**TOWN OF PORTOLA VALLEY  
ARCHITECTURAL AND SITE CONTROL COMMISSION (ASCC)  
Monday, May 11, 2015  
7:30 PM – Regular ASCC Meeting  
Historic Schoolhouse  
765 Portola Road, Portola Valley, CA 94028**

- a. Architectural Review and Site Development Permit for a New Residence, Greenhouse, and Swimming Pool, 3 Buck Meadow Drive, Ross/Tamasi Residence, File #s: 52-2014 and X9H-687

**Special Joint ASCC/Planning Commission Site Meeting, 3 Buck Meadow Drive, Preliminary Architectural Review for New Residence, Green House, Swimming Pool, and Site Development Permit X9H-687**

PRELIMINARY  
CONSTRUCTION  
STAGING PLAN

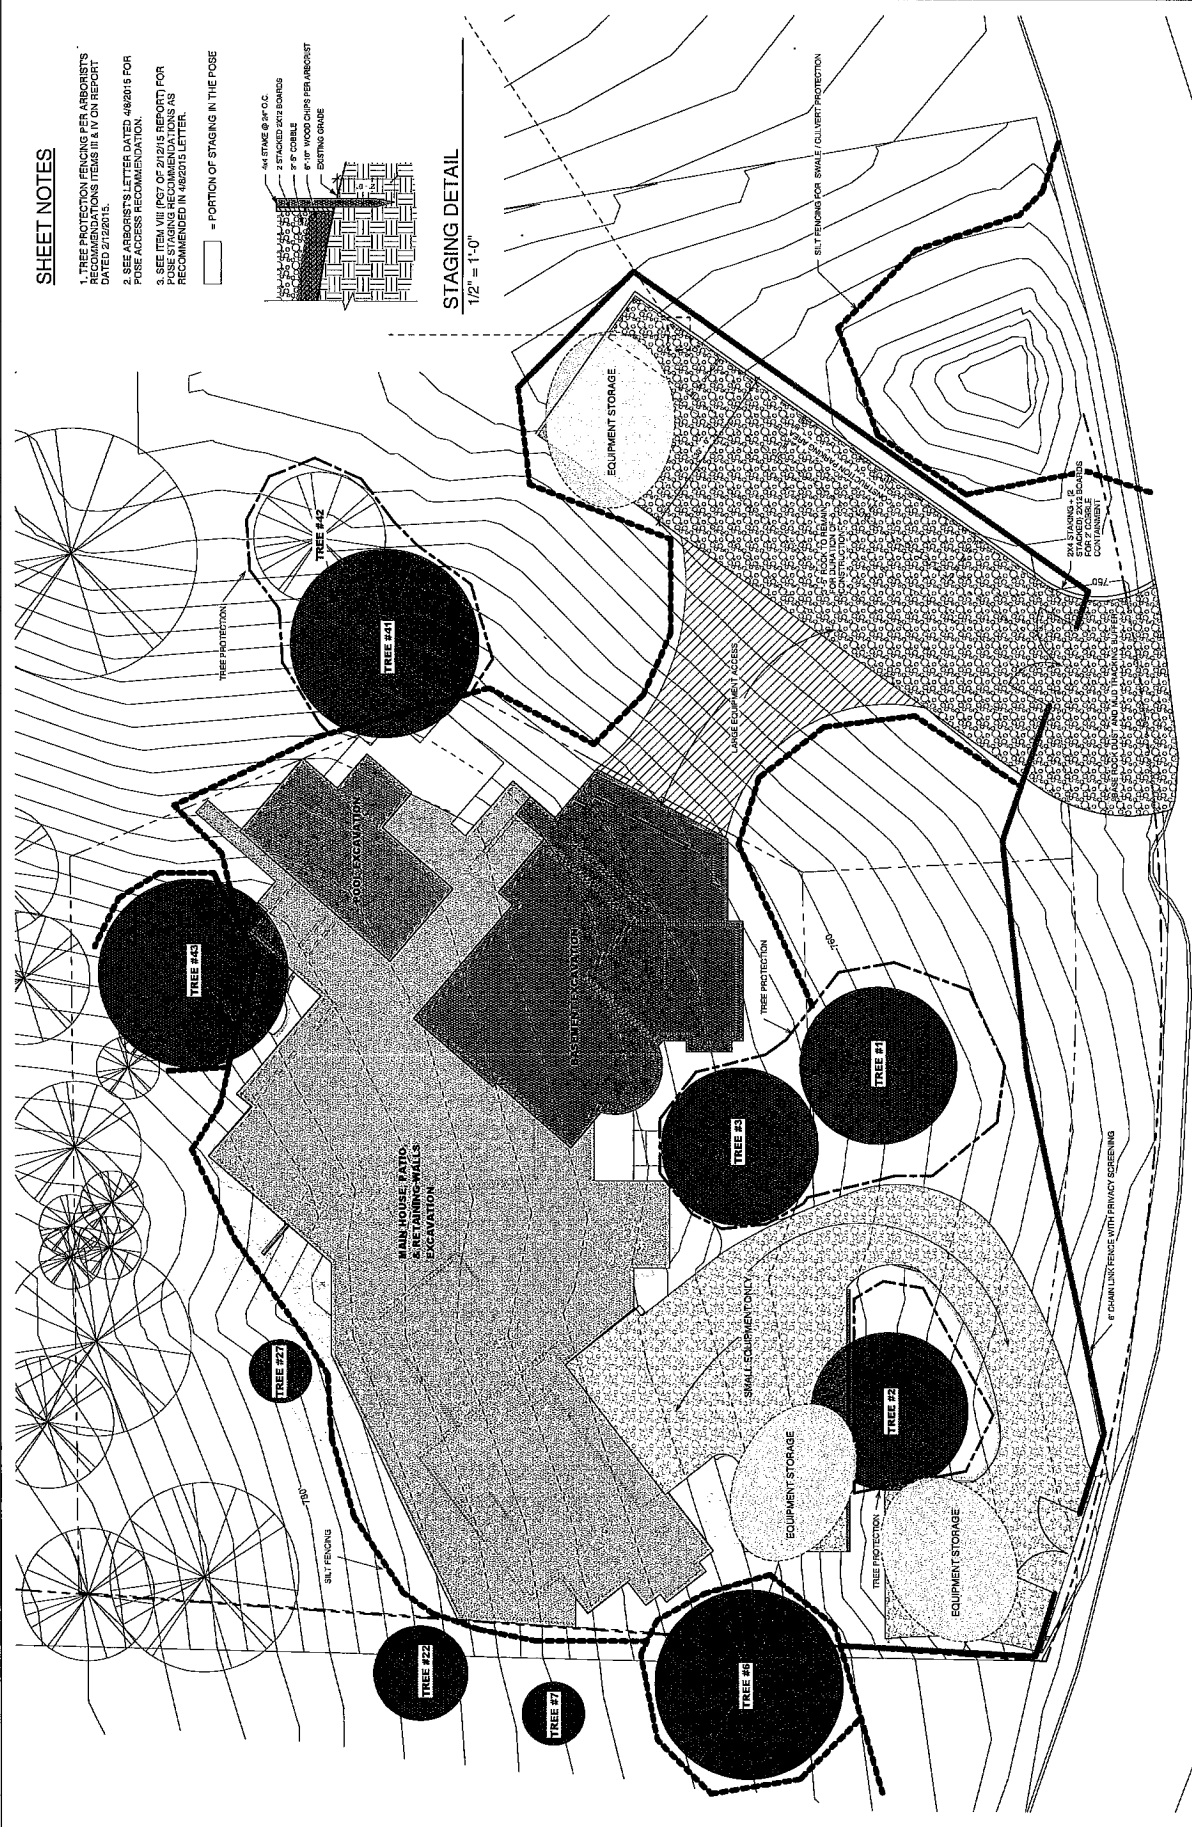
Sheet A1.02 presents a preliminary construction staging plan that proposes utilizing an area of approximately 4,700 square feet within the POSE for construction staging, parking, and large equipment access. The plan calls for creating a 30' x 110' access and equipment storage pad within the POSE. This pad would have a six- to ten-inch layer of wood chips placed on existing grade (on top of the existing grassland) and would then be covered by three to five inches of base rock/cobble. Staking and 2" x 12" boards would be installed around the pad to secure it during construction. The letter from the architect indicates that research into site sensitive methods and materials for native grass preservation is in progress.

In addition to using the rocked pad for construction staging and building site access, the applicant also proposes that the pad be used for construction parking. All construction projects in town are required to provide on-site parking where possible, and over-flow parking is typically maintained on the street where feasible. It is common and anticipated that construction projects within the subdivision utilize the streets for the over-flow of contractor parking. Parking of contractor vehicles is kept to one side of the street, and a safe throughway is maintained. For this development proposal, on-site construction parking should be proposed within the staging area located at the new driveway, rather than within the POSE. By maintaining parked vehicles within the new driveway staging area and on the street, it appears it might be possible to reduce or eliminate the need to use the staging pad for parking, and hence, reduce the amount and duration of compaction and disturbance in the POSE.

- Evaluation of the proposed methods for creation and use of the staging pad in relation to the potential survival and restoration of the grassland.
- A detailed schedule that includes a timeline for the pad/access-way creation, expected uses of the pad over the duration of construction, removal of the pad materials, restoration of the equipment access-way and grassland within the POSE.
- Technique for removal of pad materials and evaluation of potential damage to the grassland that removal of the materials could cause.
- Grading and contour restoration plan for the large equipment access area
- Grassland restoration and monitoring plan

Some adjustments to the plan will prevent unnecessary damage to the grass area and aid the trees. The 'Tree Protective Fencing' (TPF) on Site Plan A1.02 needs to be located as outlined in my report for this project dated Thursday, February 12, 2015. Additional fencing to exclude foot traffic outside of the proposed access road and staging area should be installed and connected to 'TPF' to limit soil impacts.

- **A1.02 Construction Staging Plan & Detail** – We understand the proposed staging plan will require final approval from the Town Council. We are providing a plan to the ASCC for consideration/action so we may later illustrate to the council that the plan has been carefully reviewed and that the approach chosen to preserve significant oaks is generally supported. Further research into site sensitive methods and materials for native grass preservation is in progress, and details will be provided for building permit submittal. The plan has also been submitted to the Blue Oaks HOA.

FLOOR PLANS

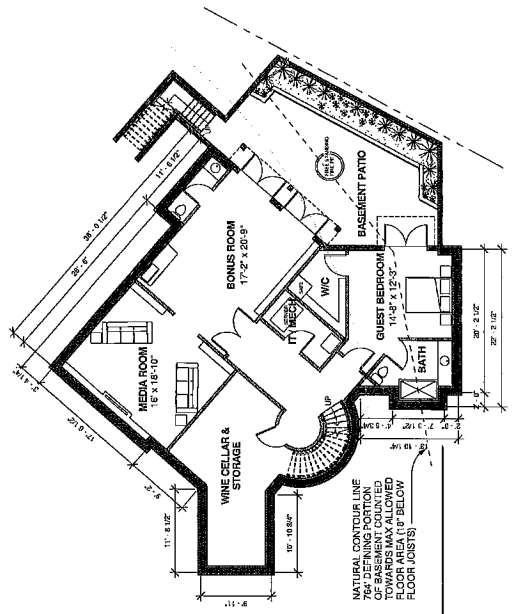
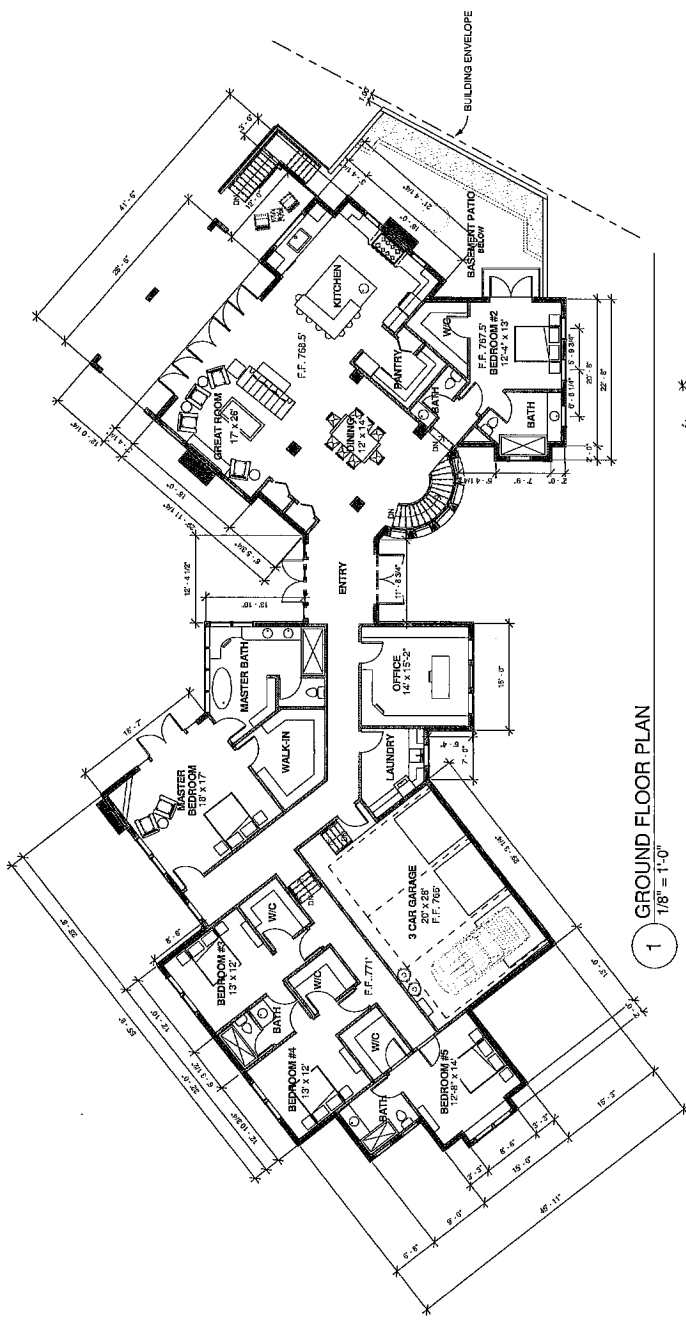
The applicant also proposes minor modifications to the floor plans (including extending the hallway at the master bedroom and adjusting the window, doors, and fireplace in the master bedroom) and adding 96 square feet to the basement area. These modifications add 34 square feet to the main level of the house and bring the total basement area to 1,799 square feet (of which 337 square feet count as floor area). The total proposed floor area for the site is 5,641 square feet and under the 5,700 square foot limit.

- **A0.03 Floor Area Calculations & A0.04 Basement Area Calculations** – Updated per floor plan changes noted below.
- **A2.01 Floor Plans** – Slight changes to floor plans per client preference – extended hallway and door location change to master bedroom, window, door, and fireplace location changes in master bedroom, door changed to NANA type in great room, and extended basement space for storage directly below entry (counts as 100% basement area).

EXTERIOR LIGHTING PLAN

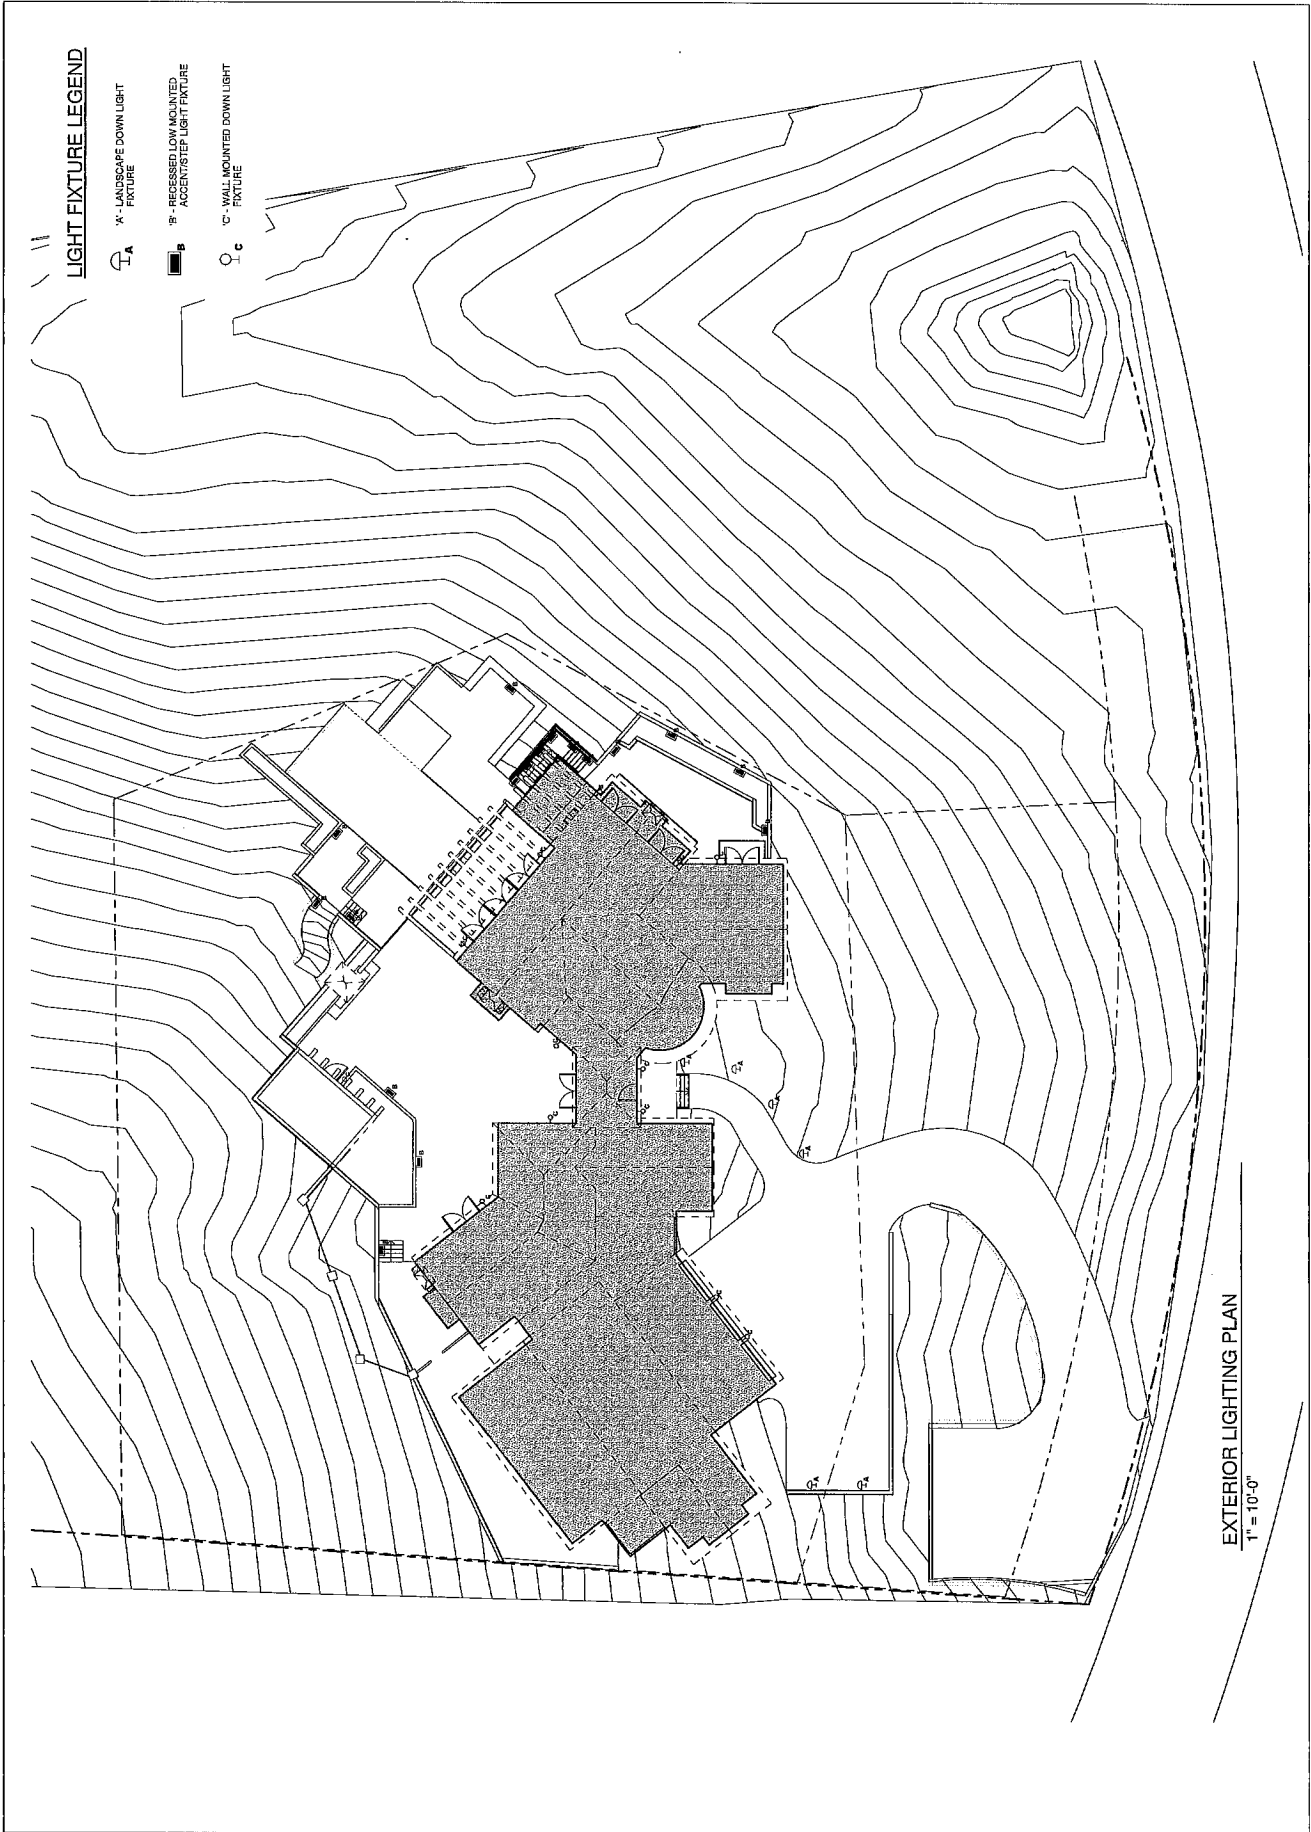
Exterior lighting (Sheet E1.01) has been modified to eliminate the lights at the guest parking pad at the driveway entrance and three of the lights at the autocourt. Additionally, two lights at the garage, two at the master bedroom, and two within the patio light well area have been removed. As suggested by commissioners at the preliminary meeting, two lights at the entry remain as proposed for aesthetic symmetry. Pool lighting has not been specified and will need to be included with the building permit submittal (Condition #2).

Proposed exterior lighting is shown on Sheet E1.01 and fixture cut sheets are identified on Sheet E1.02. The proposed fixtures and locations for house lighting appear to be in general compliance with Town guidelines; however, eliminating one light at the entry porch and one light at the master bedroom patio should be considered as only one light is required by the building code at these doors. Additionally, four lights are proposed at the front of the garage, and it appears that two lights would provide adequate lighting in this area. Reduction of site lighting should be considered inside the light-well planting area and at the guest parking pad at the driveway entrance. Pool and spa lighting will need to be specified.

- **Civil Plans 1,3,5** – Updated plans reflect the latest plan changes and their grading calcs.
- **E1.01 Exterior Lighting Plan** – Lights have been removed from the driveway parking areas both at the street level and upper autocourt, as well as reduced from 4 to 2 at the garage, reduced from 3 to 1 at the master bedroom, and 3 lights have been removed from the basement patio. Per the ASCC comments indicating an exception for main entrance lighting symmetry/aesthetics, both lights at the entry remain.

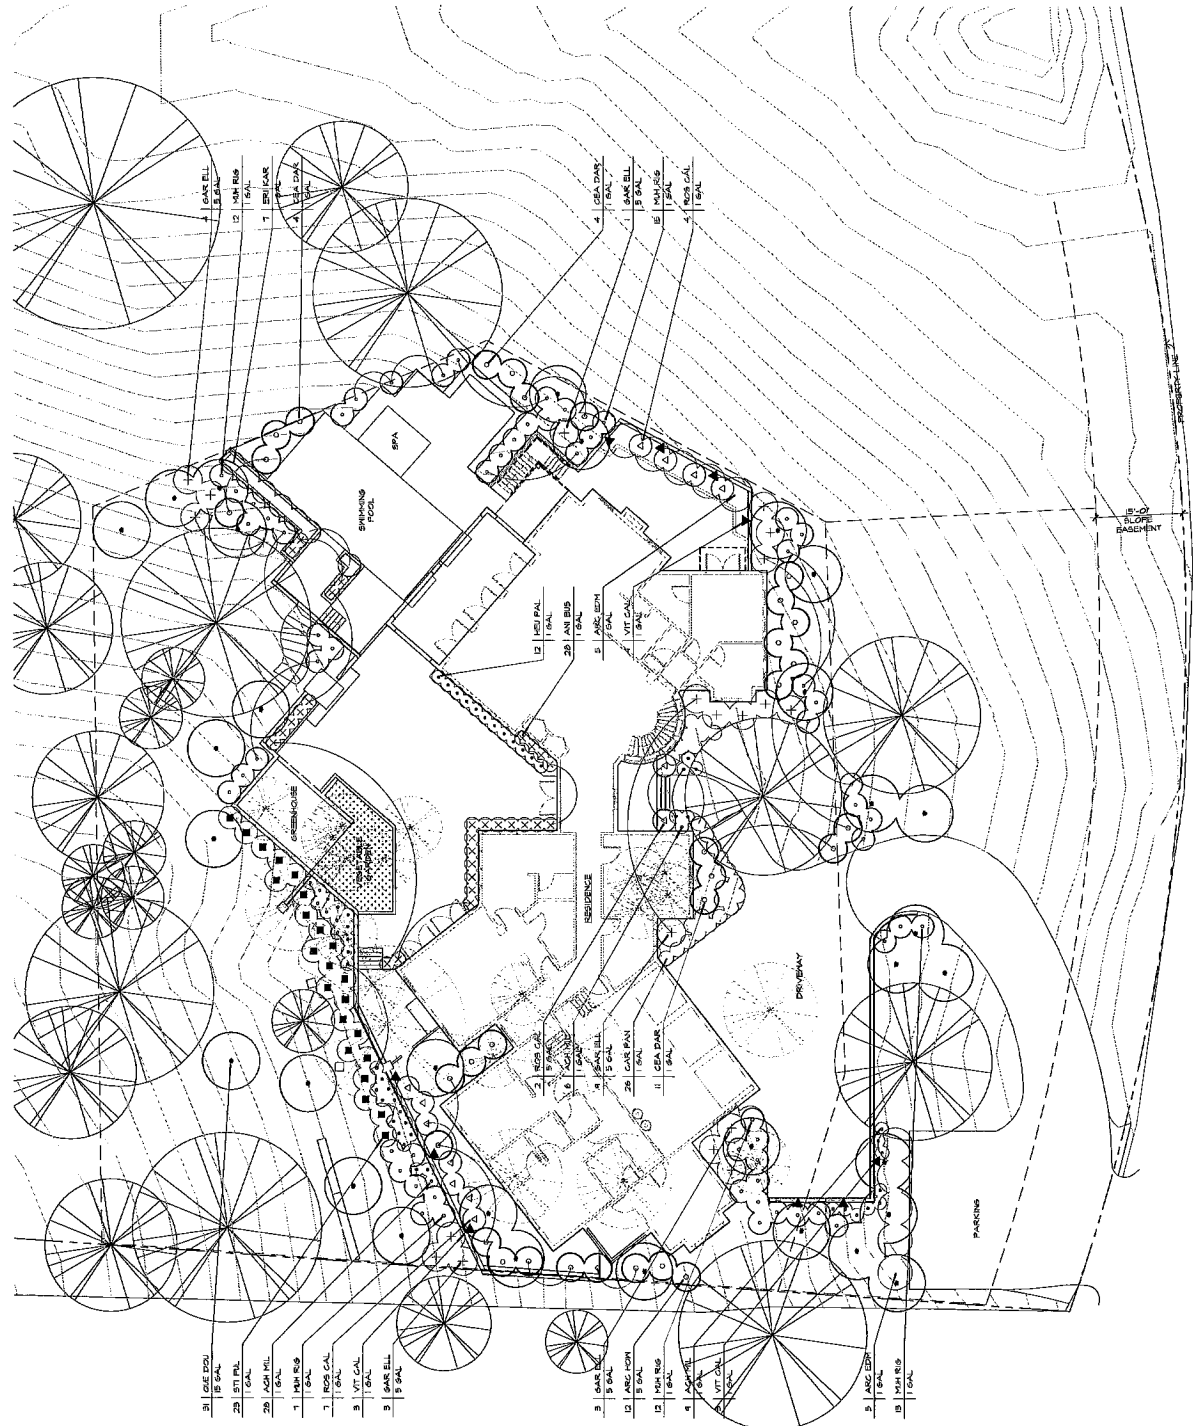
The revised, detailed landscape plan, Sheet LP.1, responds to the Commission's direction to limit or eliminate proposed screen planting within the POSE in front of the patio light well wall. All proposed planting has been removed from the POSE. The plan proposes four California grape vines that will cascade and soften the view of the wall. Additionally, the *Cistus purpureus* has been eliminated from the plan as recommended by the Conservation Committee.

As stated in the preliminary review staff report, all plantings proposed to be located outside of the building envelope must comply with the PUD approved plant list for the Combination Zone of habitation. Plantings proposed adjacent to the parking pad, autocourt, and driveway are located outside of the building envelope. Of the plant species proposed in these areas, *Muhlenbergia rigens* and *Vitis californica* are not on the approved PUD plant list and will need to be replaced with approved species (Condition #3).

- **A9.06 Chimney Options** – Model examples showing material options with new chimney styling.
- **LP1 Landscape Plan** – Updated plan shows more detail, Cistus purpureus has been eliminated, and planting along the basement light well wall has been removed.
